From: Baggett, Samuel
Sent: Thursday, January 06, 2011 12:20 PM
To: 'Fyfe, Stephen'
Cc: Goins, Dana; Mayes, Hugh; McCray, Canon
Subject: Booster Pump Gland Water System

From: McCray, Canon
Sent: Thursday, January 06, 2011 3:57 PM
To: 'stephen.fyfe@sulzer.com'
Cc: Baggett, Samuel
Subject: Additional Vendor Data for GW Components
Attachments: CR3 Feedwater Booster Pump GW Mods.doc; Leslie 20_2_5_1_3.pdf; 10-1.4.3.1ALT15-SH001.pdf; 01869-000.pdf; 01872-000.pdf; Ashcroft DU-3-1379.pdf; Dragon Catalog_Model_10F.pdf; Leslie 20_2_5_1.pdf

CR3 FEEDWATER BOOSTER PUMP GLAND WATER SYSTEM MODIFICATIONS

NEW FWP-1A Glandwater Piping

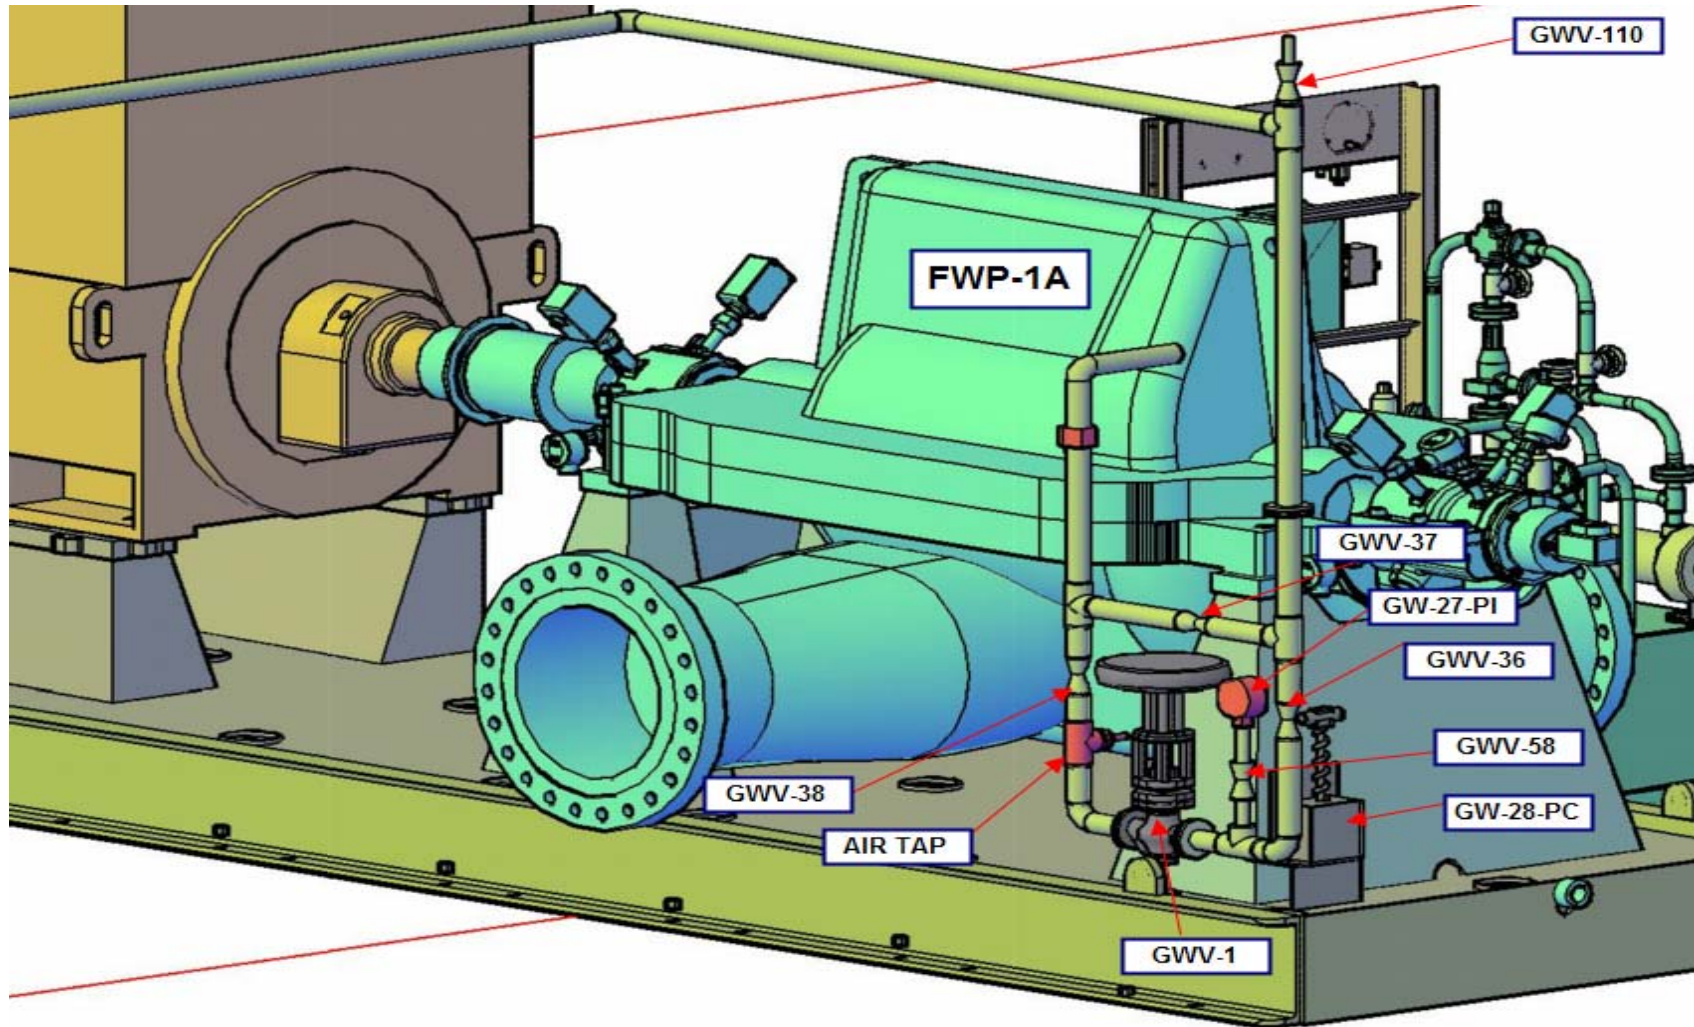
The new proposed piping configuration which will simply relocate the GW Control components to the south east end of the new skids is shown below:
